SSDA REPORT

North Sydney Public School 182 Pacific Highway, North Sydney NSW 2060

Report Prepared for: Department of Education
Report Prepared by: Lucy Alderson
Our Ref: AN021-216878 SINSW
Date: 27 August 2021

DRAWING NUMBER
SD-1109

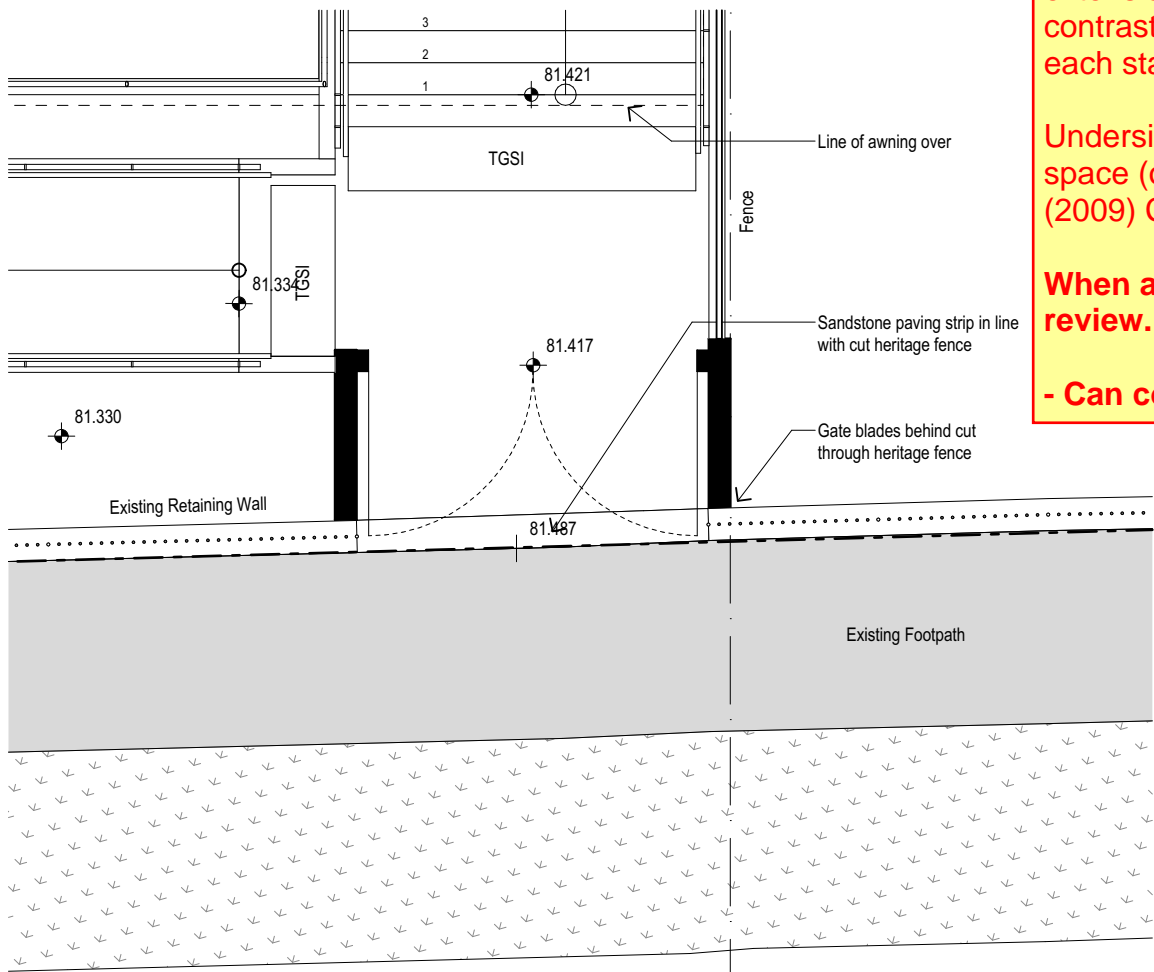
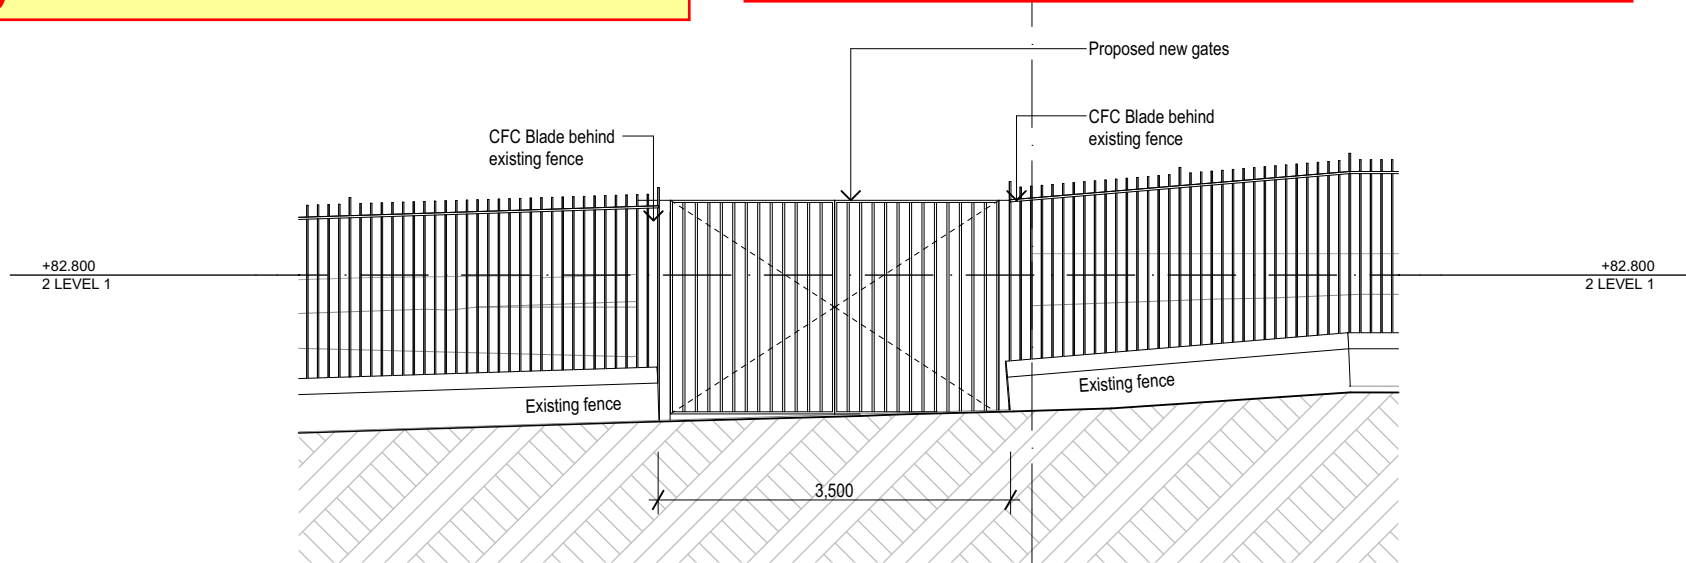
Stairways - AS 1428.1 (2009), Clause 11
Designers to ensure stair details meet the requirements of AS1428.1 (2009), Clause 11, including handrails, handrail extensions, opaque risers, nosing strips, 30% luminance contrasting nosing strips and TGSIs at the top and bottom of each stair.

Undersides of all stairways on an accessible path/circulation space (overhead hazard) shall comply with AS 1428.4.1 (2009) Clause 2.6.

Ramps - AS 1428.1 (2009), Clause 10.3
Ramp shall meet the requirements of AS1428.1 (2009), Clause 10.3 including:

Plans indicate a possible overhead hazard below the stair. Where there are impediments or hazards with less than 2000mm height clearance in an accessible open public space with no clearly defined continuous accessible path of travel, contact with overhead hazard shall be prevented by a suitable barrier complying with AS/NZS 1428.4.1 (2009), Clause 2.6(a)(b) and Figure 2.6(A)(B)

DRAWING NUMBER **SD-2003** REVISION **G**

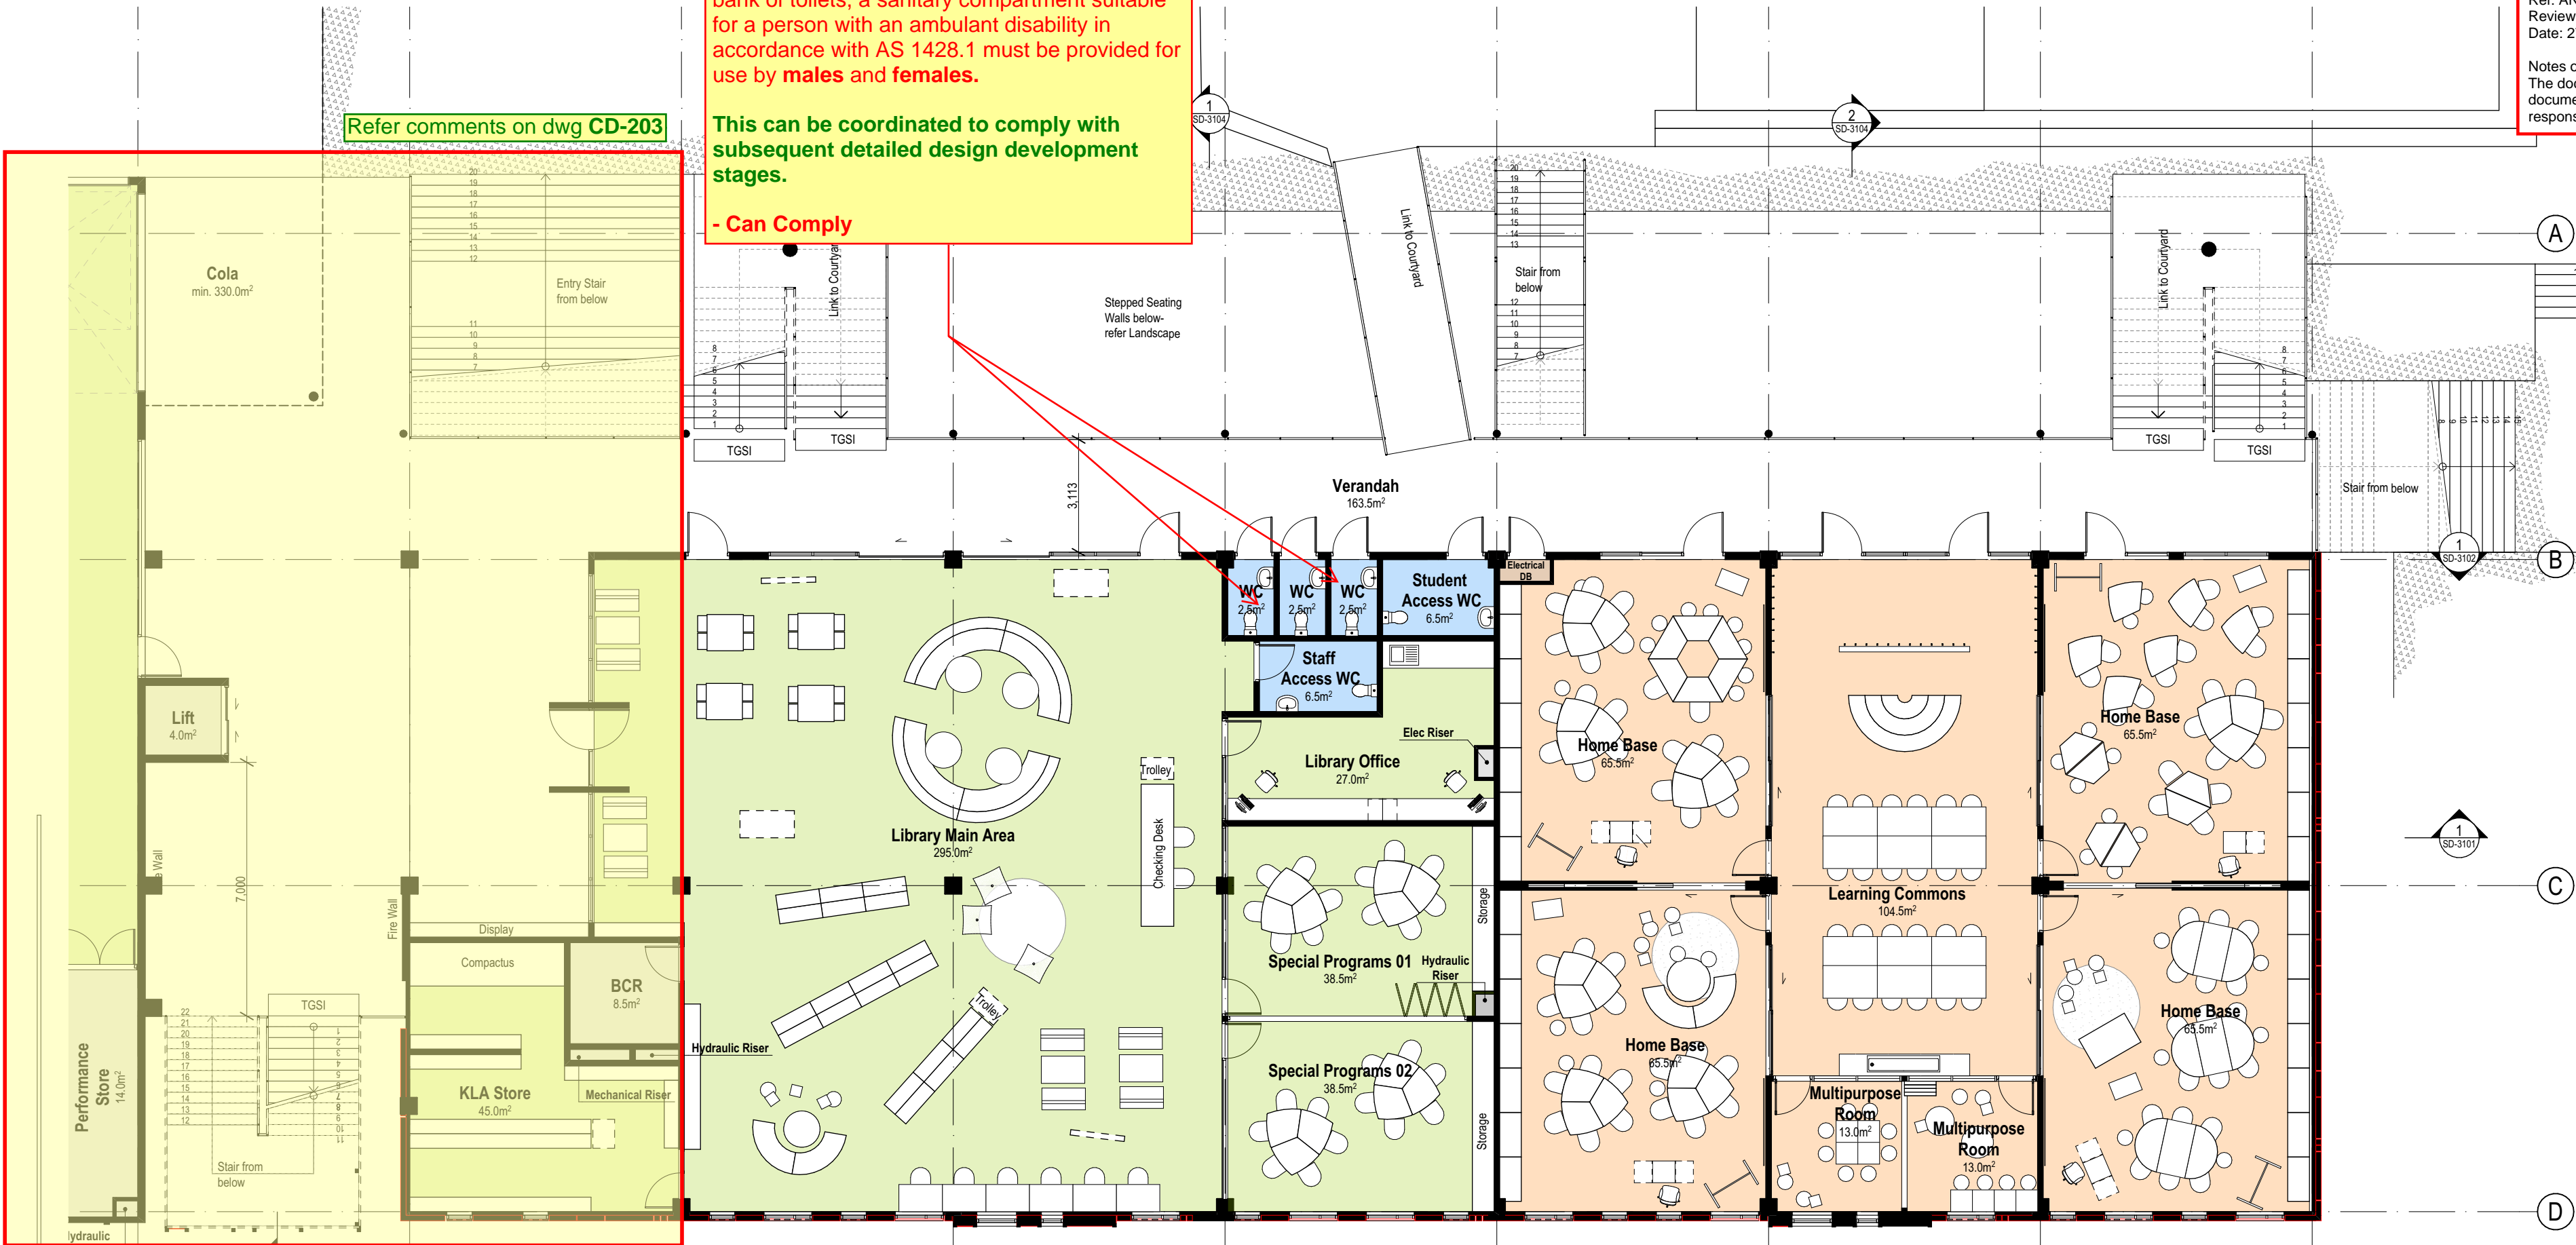
Refer comments on dwg CD-203

DRAWING NUMBER
SD-2004

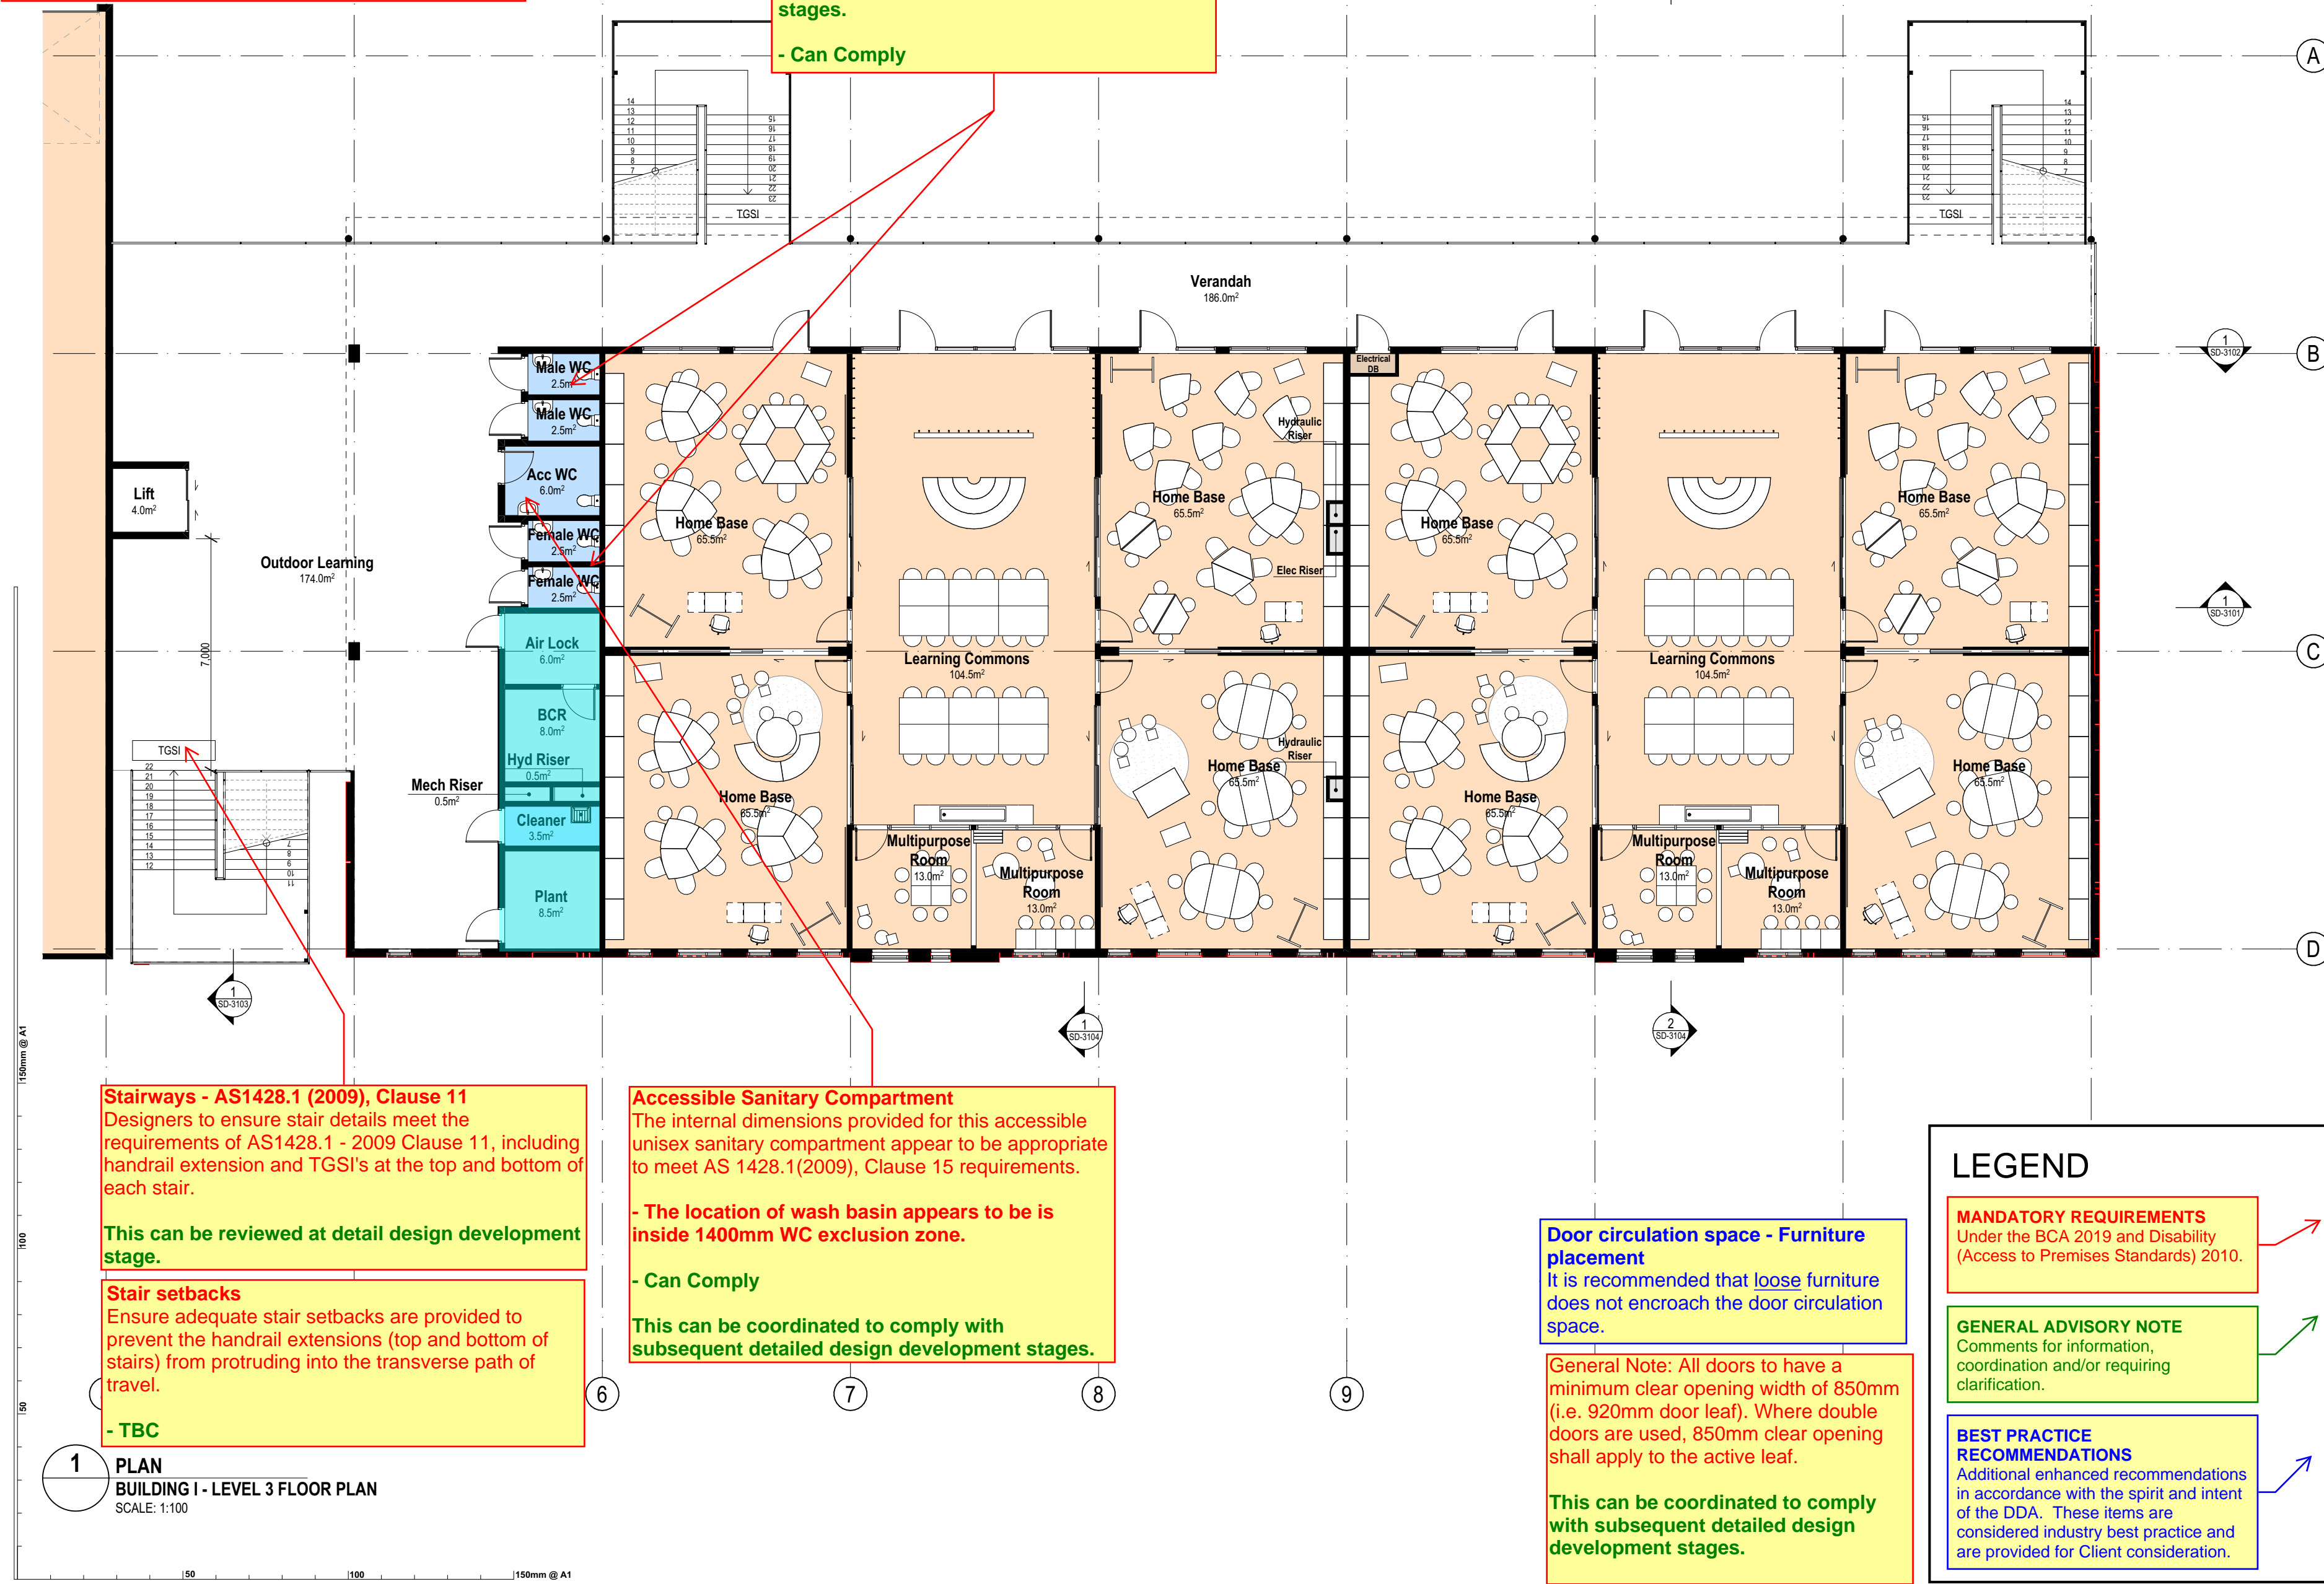
Exemptions - BCA, Part D3.4
The following areas are not required to be accessible:
(a) An area where access would be inappropriate because of the particular purpose for which the area is used.
(b) An area that would pose a health or safety risk for people with a disability.
(c) Any path of travel providing access only to an area exempted by (a) or (b).

Area subject to D3.4 Exemption identification:
